July 30, 1991
Fort St. Vrain
Unit No. 1
P-91248

SUBJECT: RESPONSE TO REQUEST FOR ADDITIONAL INFORMATION -
DECOMMISSIONING TECHNICAL SPECIFICATIONS AND REPRESENTATIVE
COST ESTIMATE

RESPONSE TO REQUEST FOR ADDITIONAL INFORMATION

ESTIMATED TRITIUM INVENTORY IN PCRV WATER SYSTEM

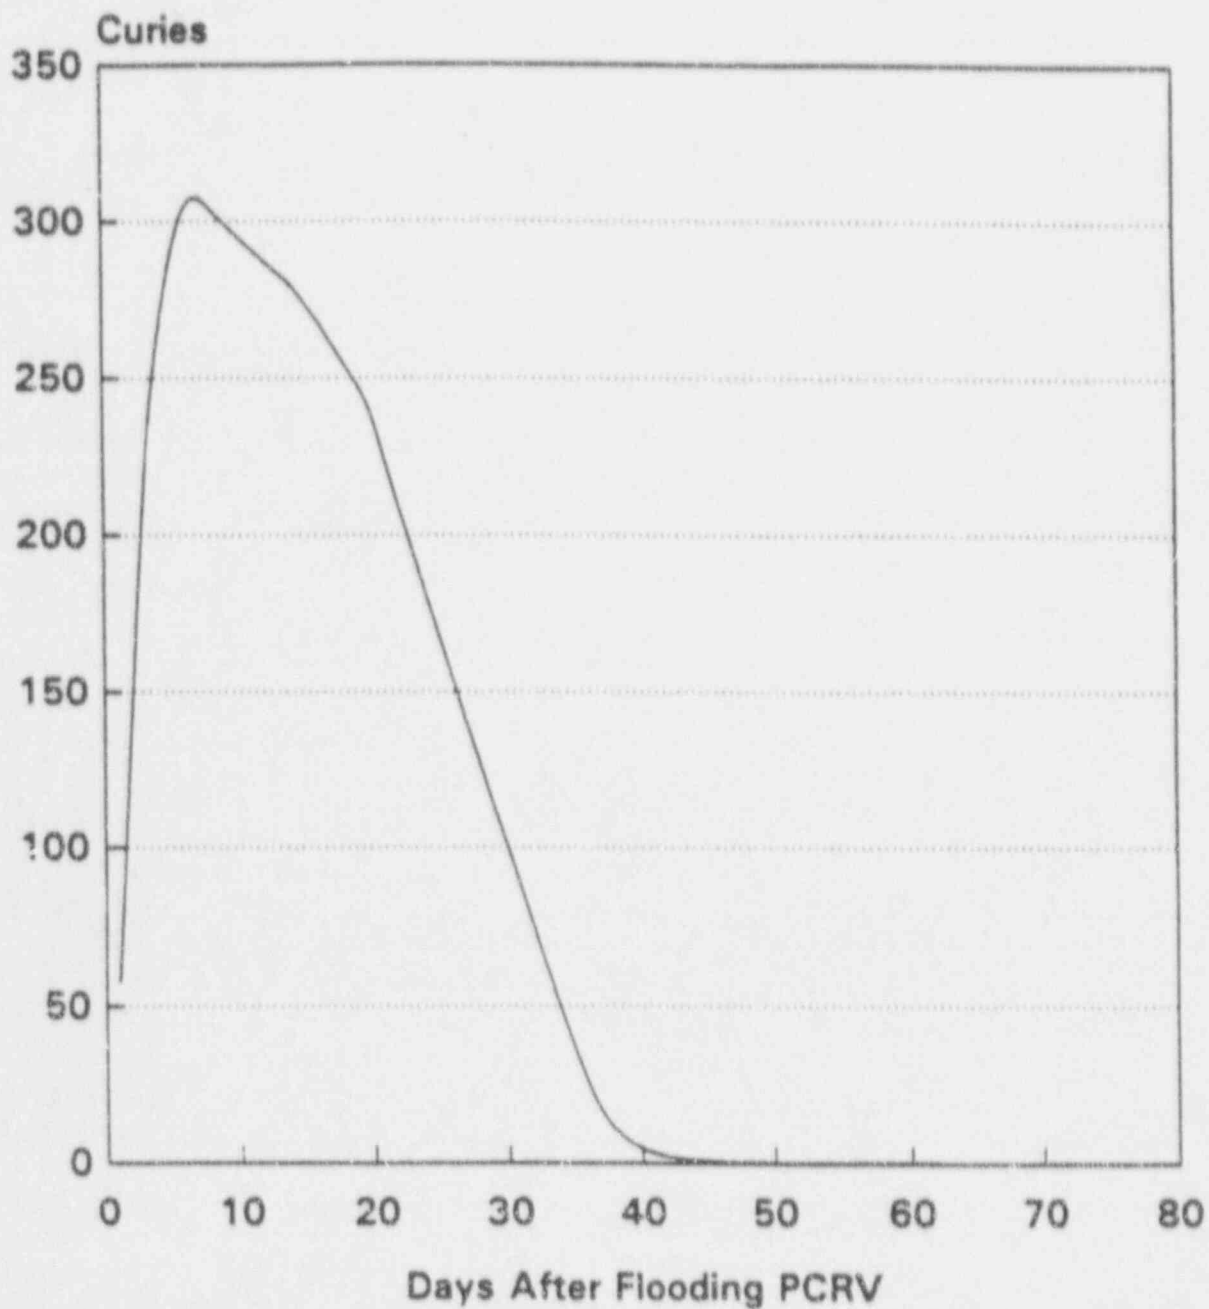
NRC Question 9: Page 3.4-2, Surveillance Requirements,
SR 3.4.2

The surveillance frequency should be daily while water is being used for shielding.

The majority of the tritium within the PCRV is contained within the activated graphite blocks. PSC anticipates that the release of tritium into the shield water will occur within a very short time after the graphite blocks are immersed. During this initial immersion period, daily sampling is warranted to monitor the tritium level and ensure that the maximum limiting concentration is not exceeded.

Tritium levels in the PCRV shield water will be reduced by a feed and bleed operation. As shown on the attached Figure (provided in the Proposed Decommissioning Plan as Figure 3.3-1), tritium concentration is expected to peak within 10 days after flooding the PCRV, and to be substantially reduced (to less than 0.1 microcuries/cc) within 40 days after flooding the PCRV. Tritium concentration is expected to continue to decrease thereafter.

Based on the above, PSC proposes to revise Surveillance Requirements SR 3.4.1 and 3.4.2 to require daily sampling during initial filling of the PCRV with shielding water and until tritium concentration decreases below 0.1 microcuries/cc for three consecutive days. After this period (estimated to be approximately 40 days after flooding), weekly sampling will be required until tritium concentration decreases below 0.01 microcuries/cc. After this point is reached, no further sampling will be required.
